Service Bulletin

Revised Information: Announcement of DX-D 100, version 3.0

DD+DIS227.12E

Figure 12

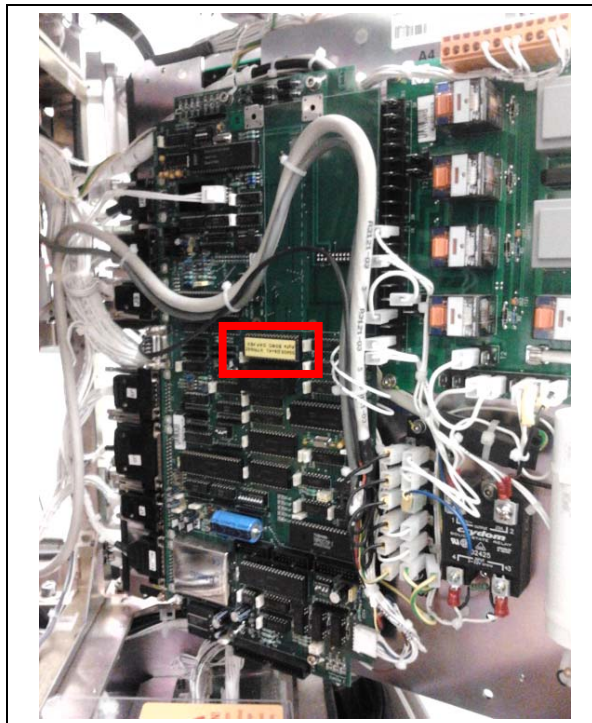
- (14) Remove EEPROM v42 (U24) carefully.

Make sure to lift the EEPROM together at both sides because the pins are fragile!

Figure 13

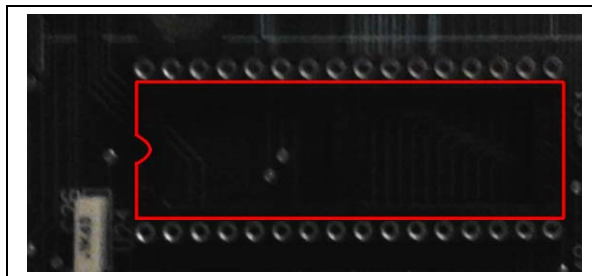
- (15) Replace with EEPROM v. 62.

Make sure to correctly position the EEPROM (opening to the left).
